State, Federal and Tribal Fishery Agencies Joint Technical Staff

May 29, 2003

The Bonneville Power Administration has developed and distributed a proposal to the Corps of Engineers Study Review Work Group (SRWG) to discontinue the 1% peak turbine efficiency turbine operating limits included in the NMFS Biological Opinion. We understand and support the ongoing process of evaluating hydrosystem operations and how they relate to fish survival. However, we find that the available evidence strongly suggests that operations outside the 1% of peak efficiency would be detrimental to fish. Therefore we cannot support the draft proposal submitted by BPA to discontinue operations within the 1% of peak efficiency in all mainstem federal projects. We support the implementation of the Biological Opinion (BiOp) measures requiring that turbines operate within 1% of their efficiency range.

Figure 1. Mean survival and 95% confidence intervals for Kaplan-type turbines operated inside and outside of the 1% of peak efficiency bounds for Columbia/Snake River projects [Data from Skalski et al. (2002, Table A.1)].

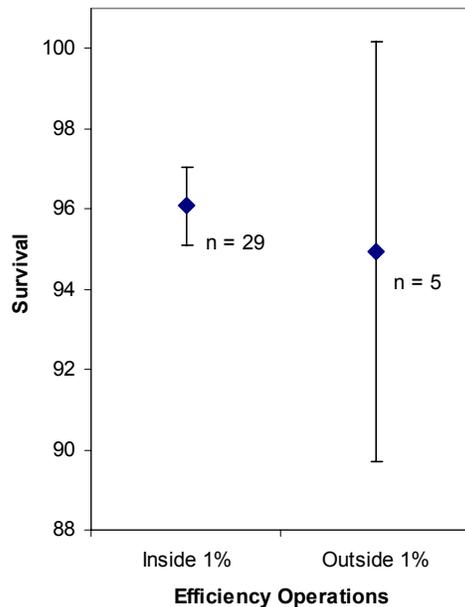
The data evaluated in Skalski et al. (2002) provide a second basis for maintaining the 1% efficiency limits. While their analysis was primarily focused on evaluating the academic question of whether peak survival coincides with peak efficiency, they do provide a useful summary of more recent data on the relevant operational question of maintaining the 1% of peak efficiency limits. Based on the data provided in Skalski et al. (2002, Table A.1), mean survival is reduced by 1.13% (for Columbia/Snake River projects) to 1.64% (for all projects) when Kaplan-type turbines are operated beyond the 1% of peak efficiency limits (Figures 1 and 2). In addition, survival decreases linearly as turbines are operated beyond peak efficiency for Columbia/Snake River projects (Figure 3).
